G.A.V. & ASSOCIATES, INC.
 DIMENSION AND LAYOUT PLAN
 2260 CROOKS ROAD - PARCEL NO. 15-29-276-001
 SECTION: 29
 CITY OF ROCHESTER HILLS
 OAKLAND COUNTY
 MICHIGAN

J2023-0144
 PSP2024-0037
 Revision #1
 Received 1/8/2025
 City of Rochester Hills
 Planning & Economic
 Development

site plan.pdf Markup Summary

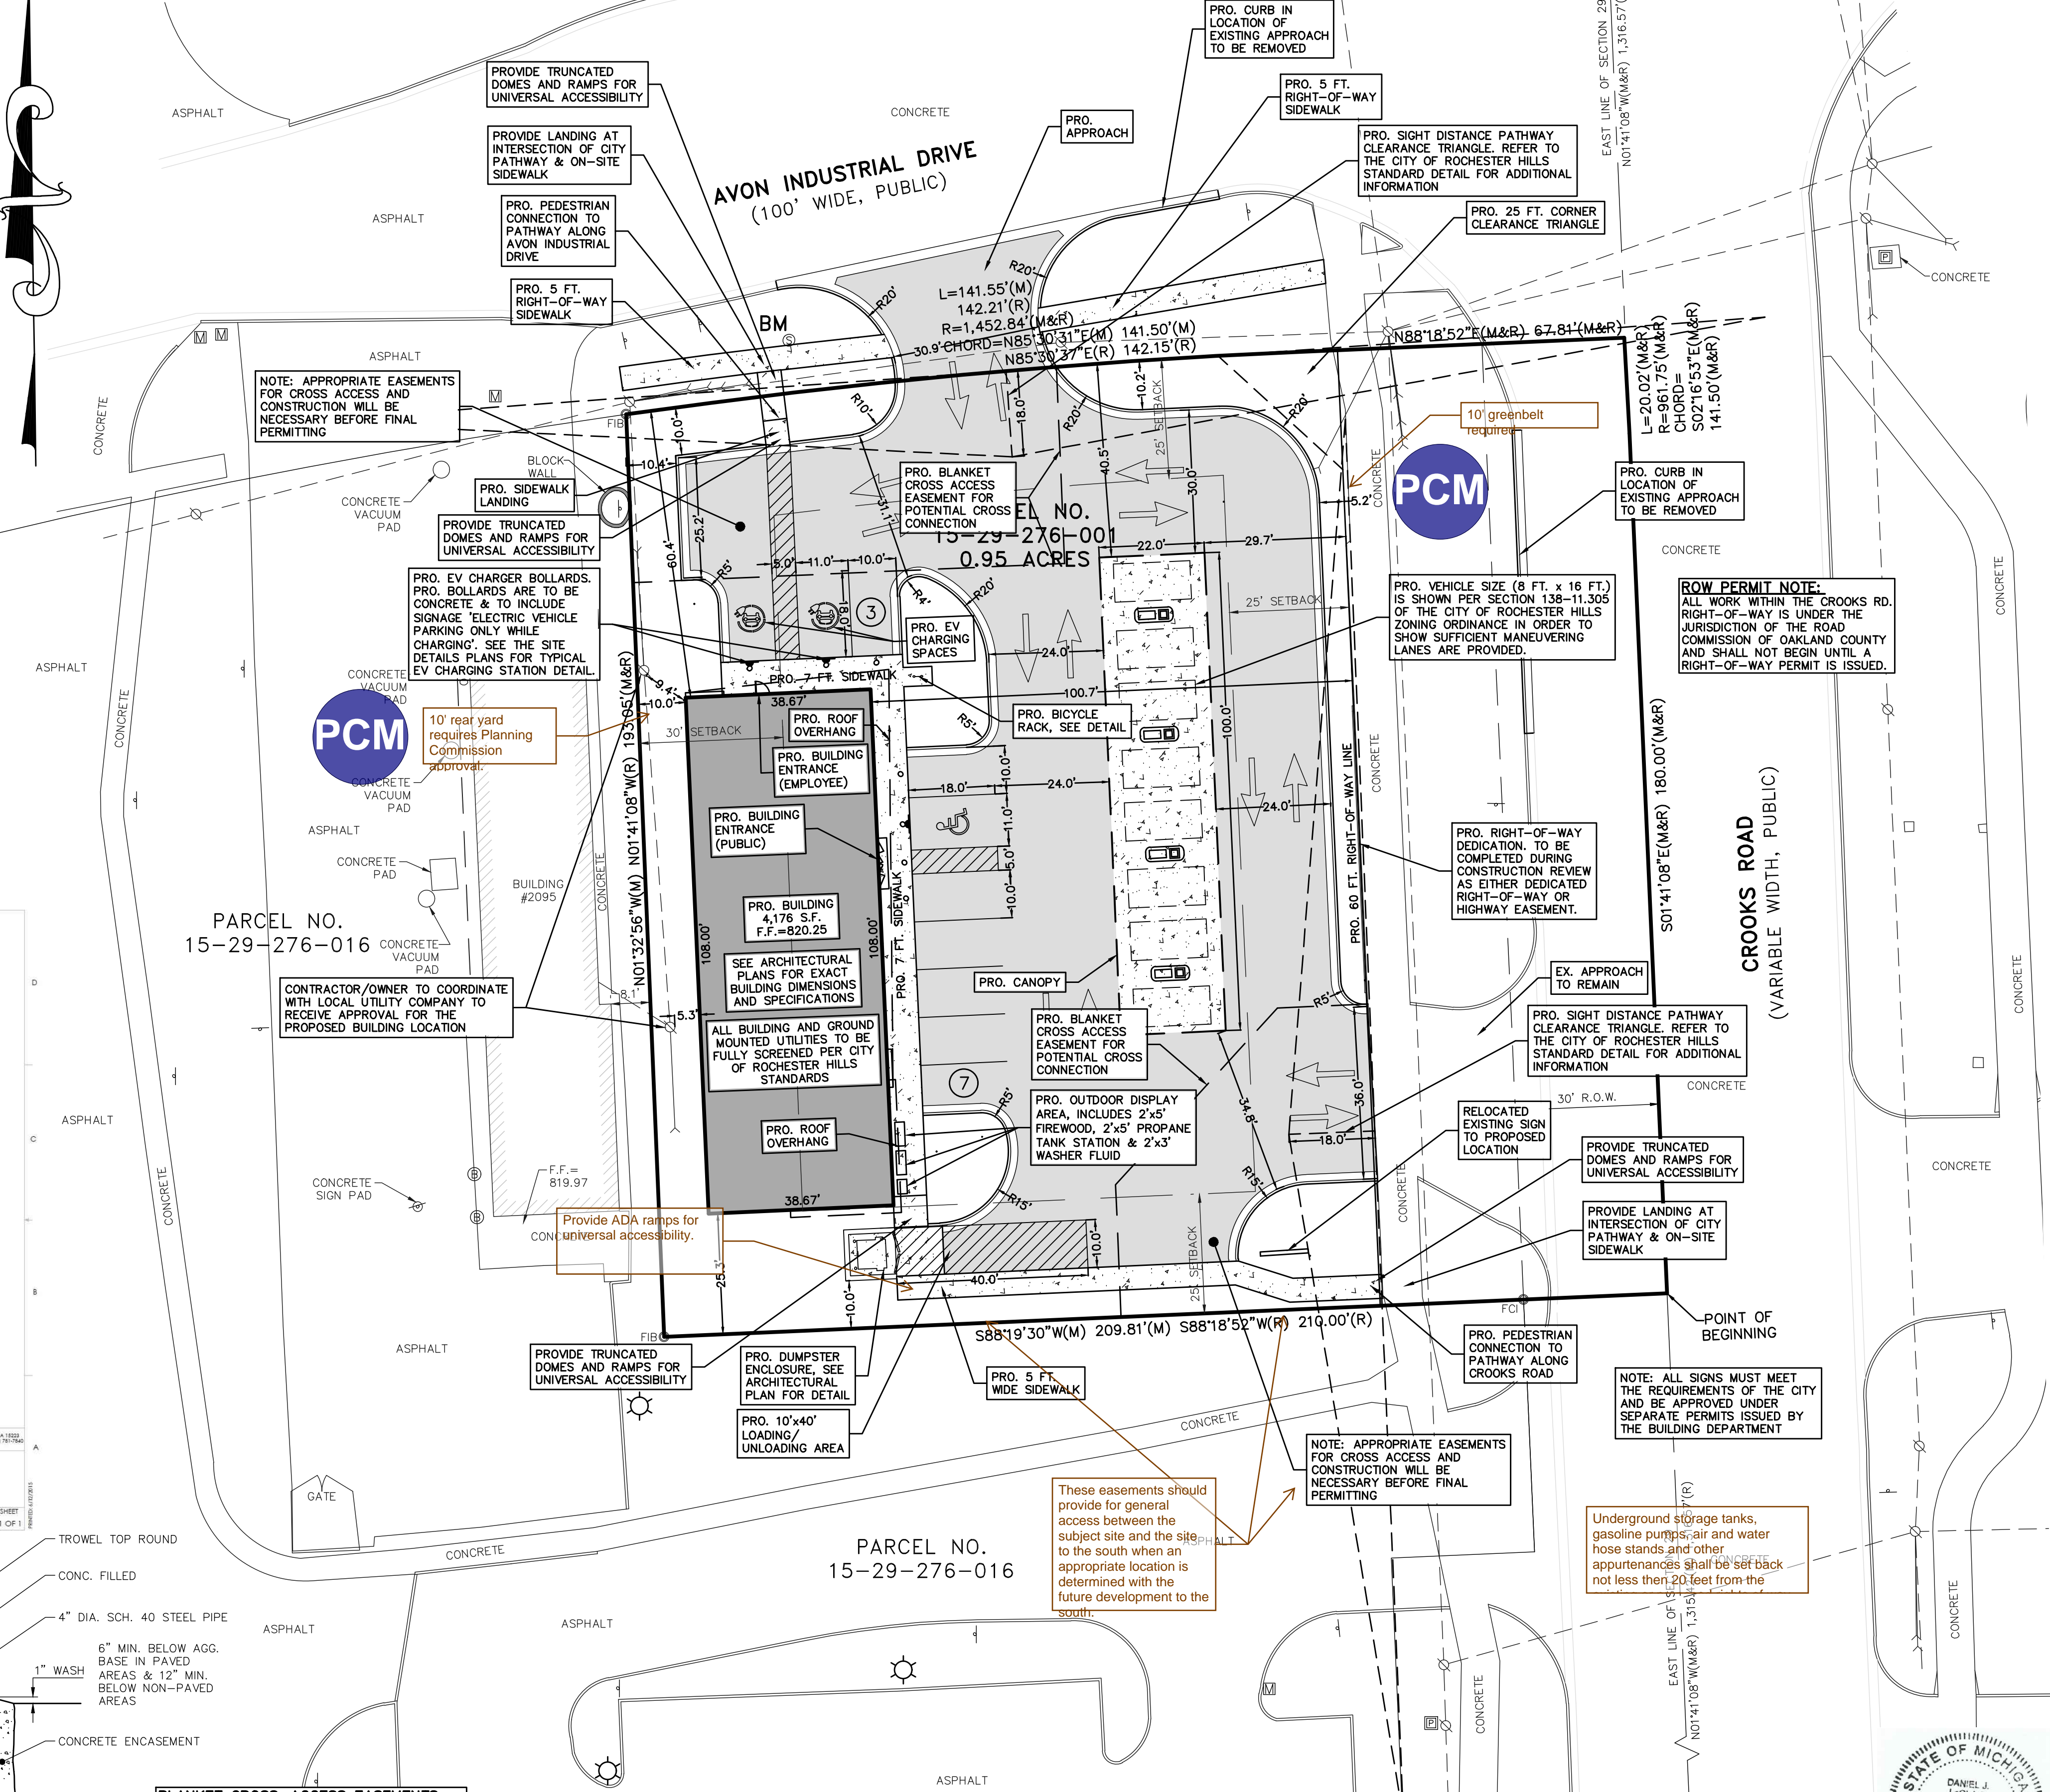
To match RH Gateway and Streetscape Master Plan

TRUCK TURNING PLAN

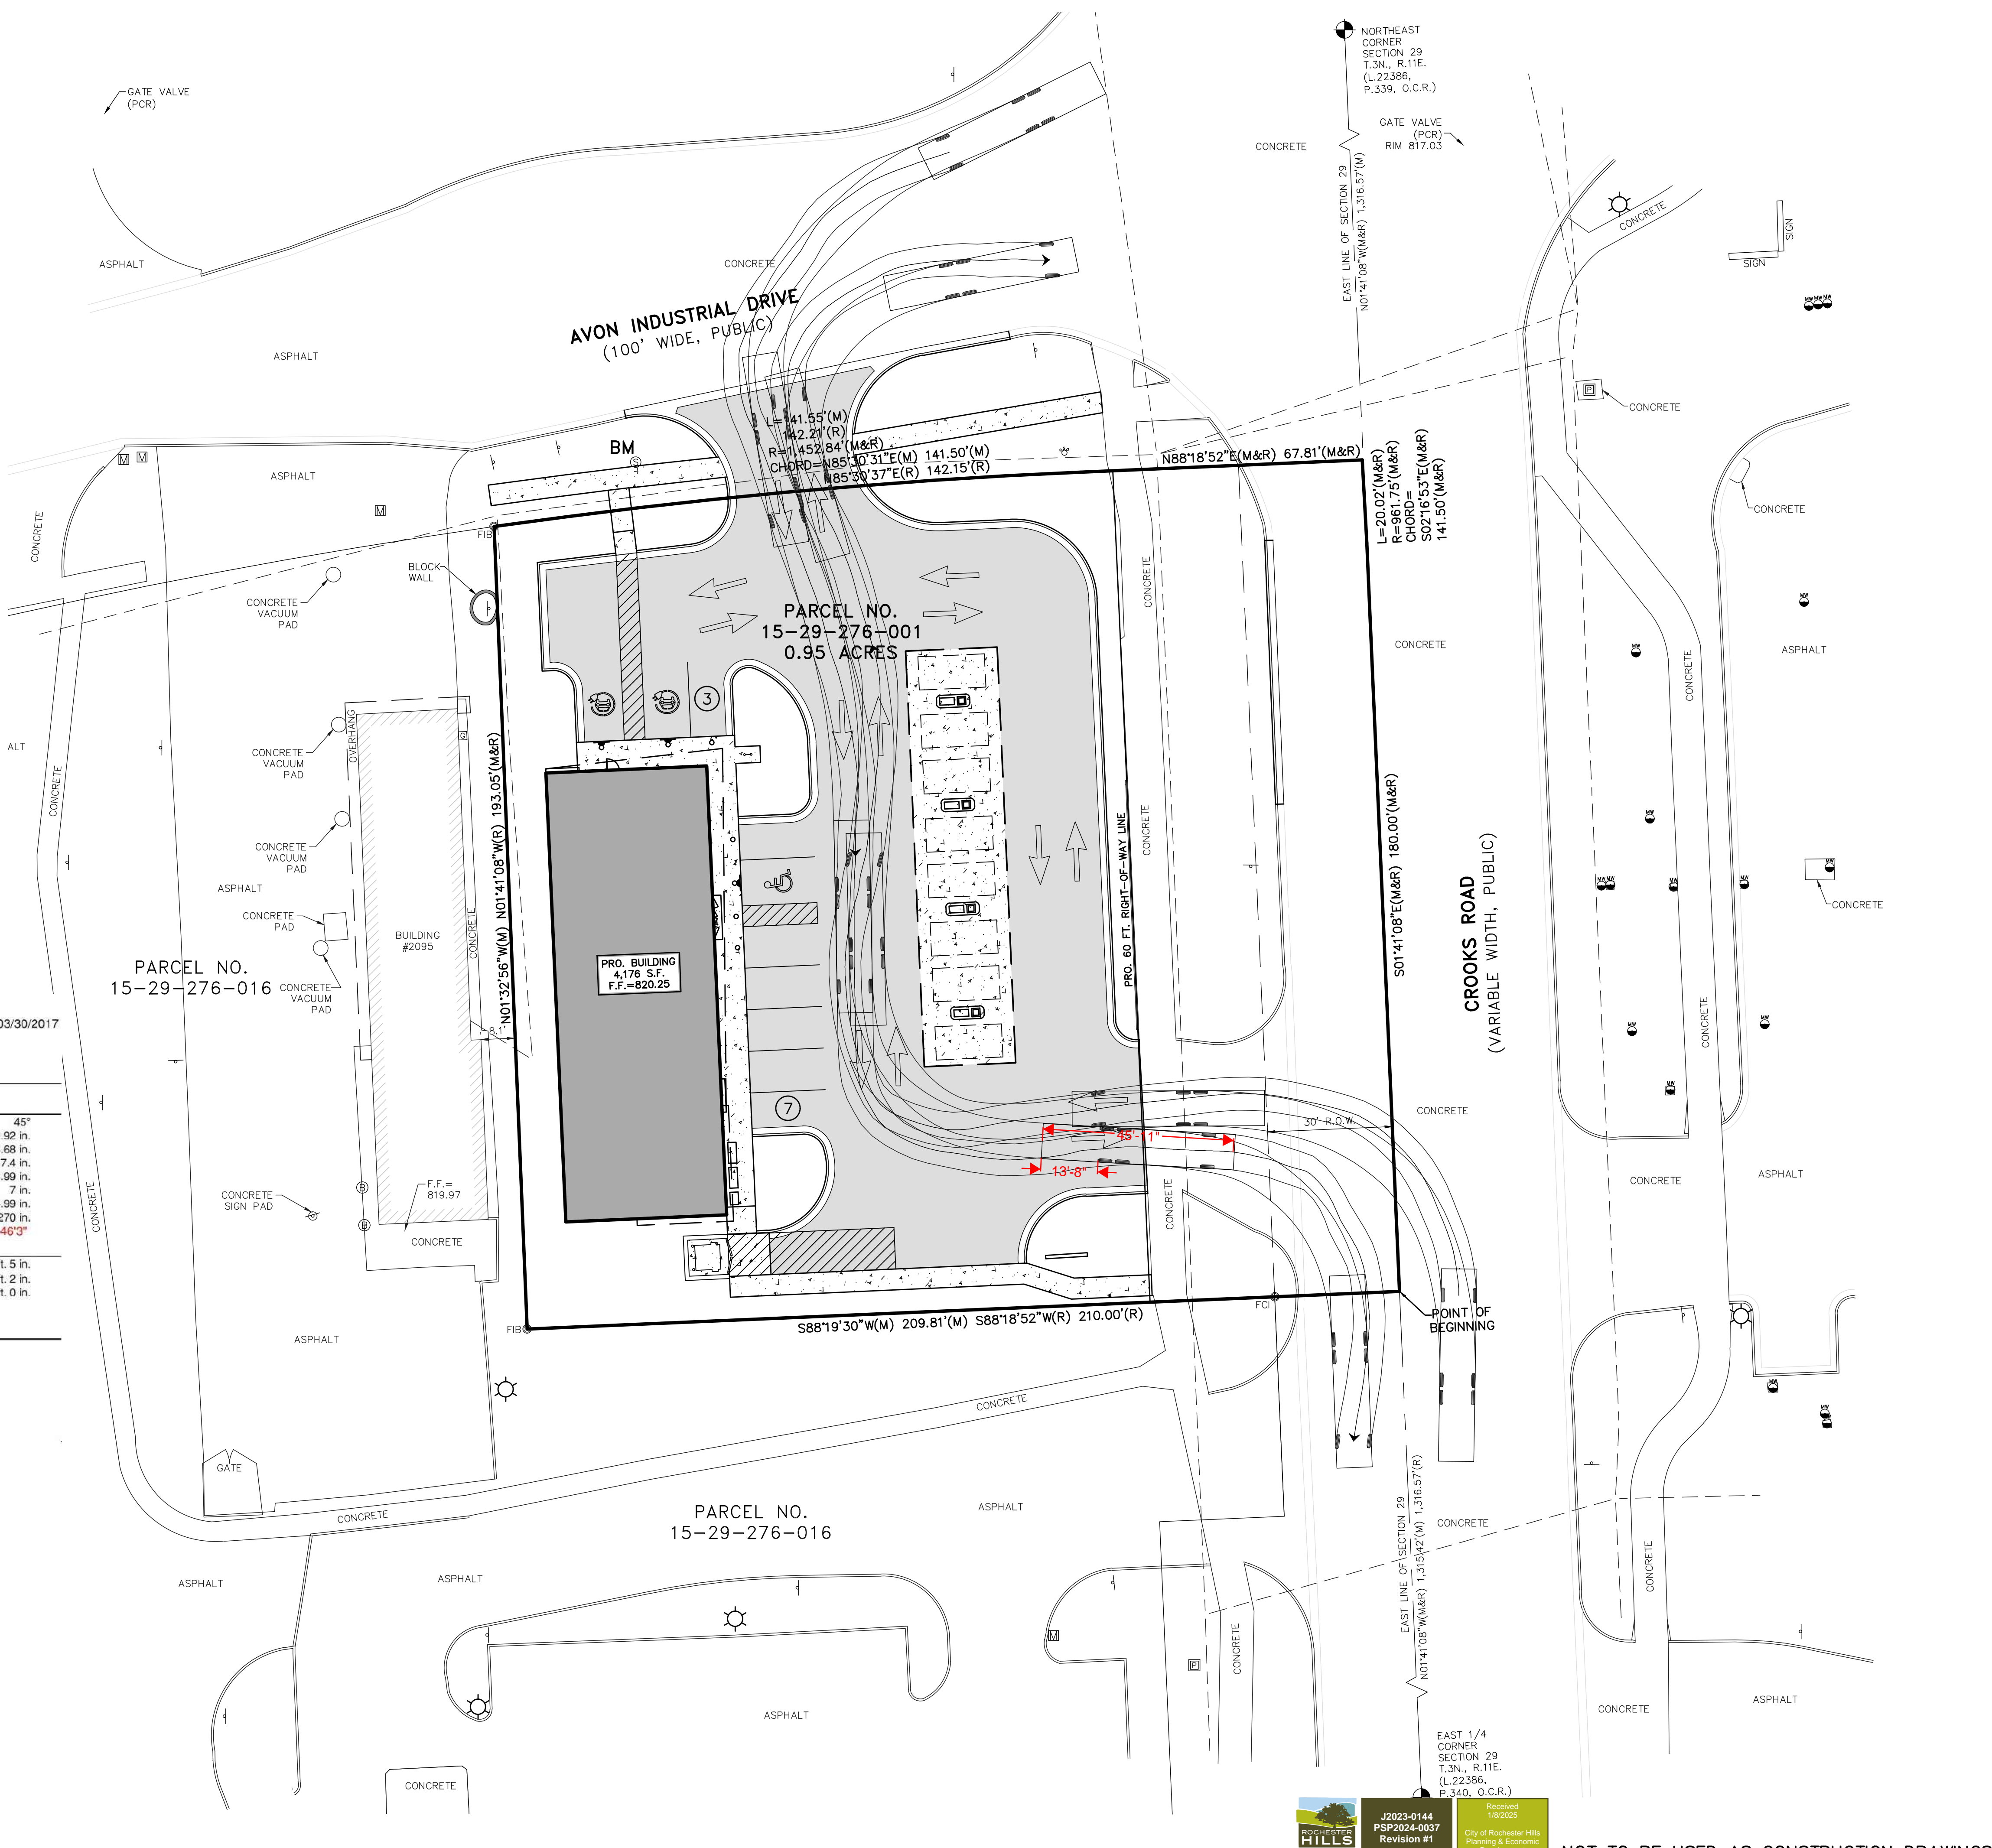
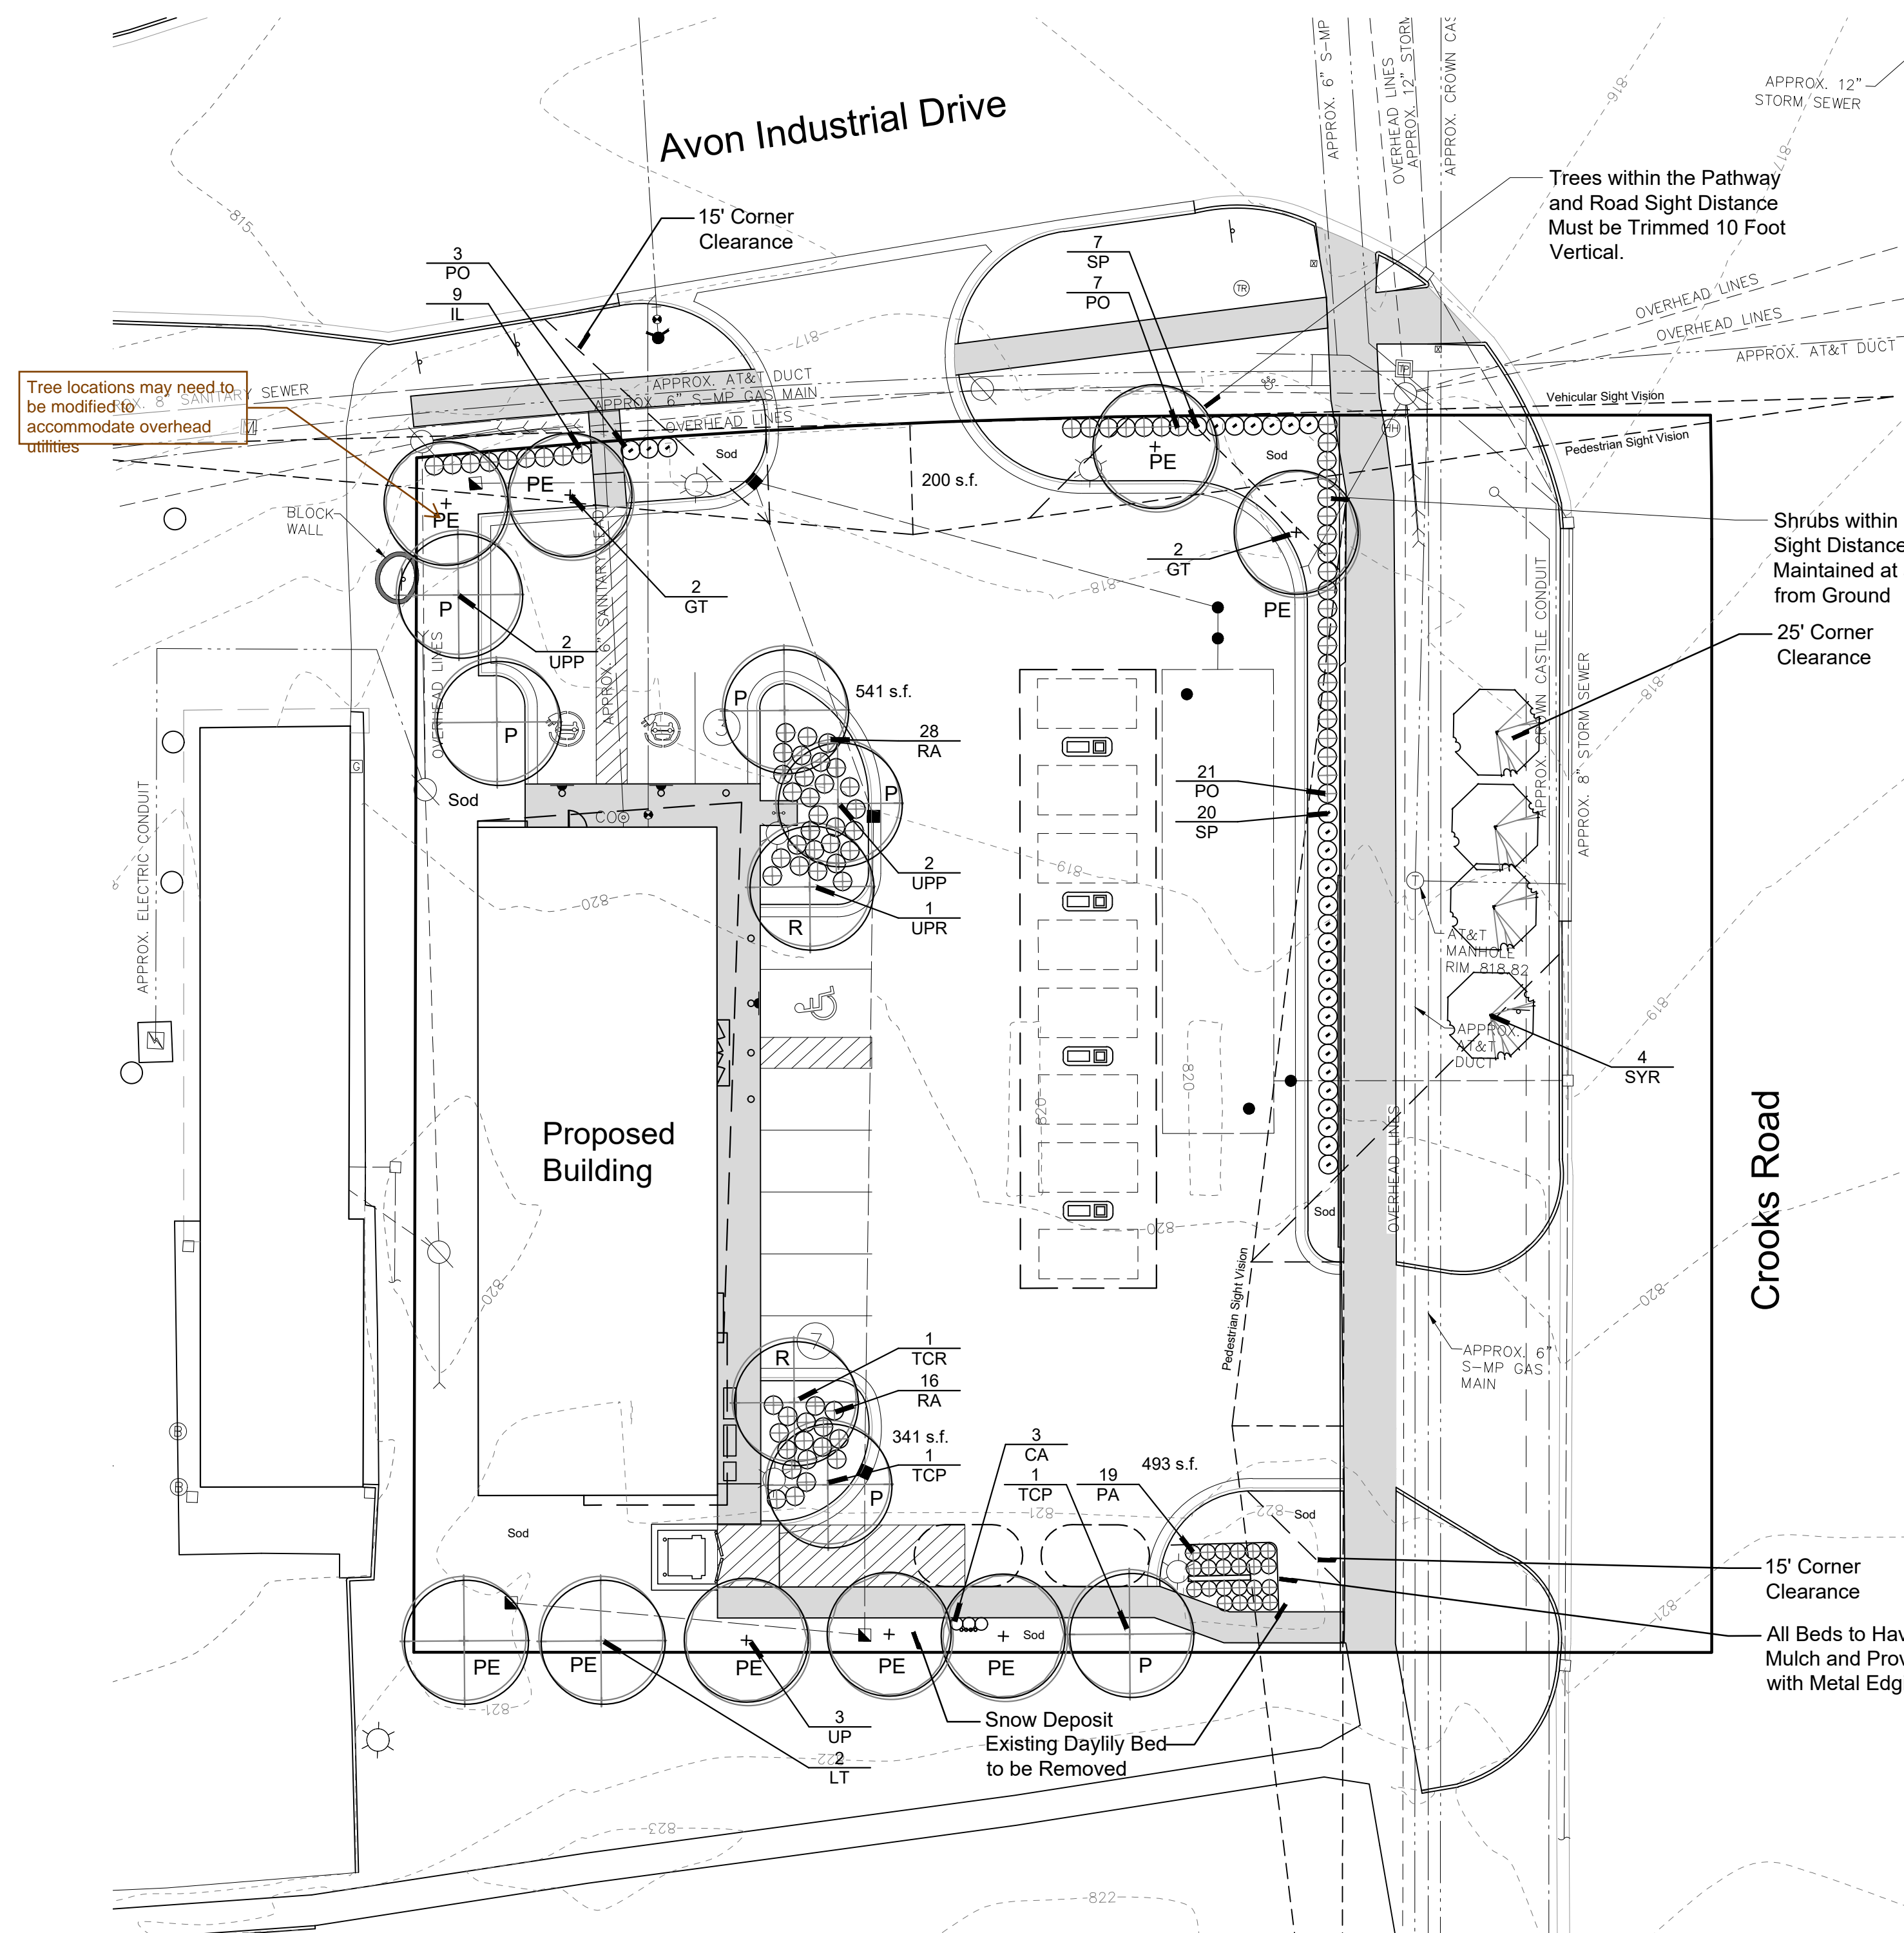
PROVIDE THE FOLLOWING INFORMATION ON THIS SHEET: 1.CONSTRUCTION TYPE AND SQUARE FOOTAGE OF THE BUILDING 2.WIDTH OF PROPOSED DRIVES MEASURED FROM FRONT OF CURB 3.LOCATION OF ALL EXISTING AND PROPOSED FIRE HYDRANTS 4.LOCATION OF EXISTING OR PROPOSED UNDERGROUND WATER DETENTION 5.HEIGHT OF ANY OVERHANGS INTO THE FIRE APPARATUS ACCESS ROAD 6.PROPOSED LOCATION OF DUMPSTERS 7. ~~LAND DRAINAGE - USE THE TURNING RADII BELOW - YOUR VEHICLE IS A MID-MOUNT AERIAL PLATFORM, NOT A REAR MOUNT LADDER~~

Comments:
95' PAP - City of Rochester Hills
Rear Overhang - 16 feet
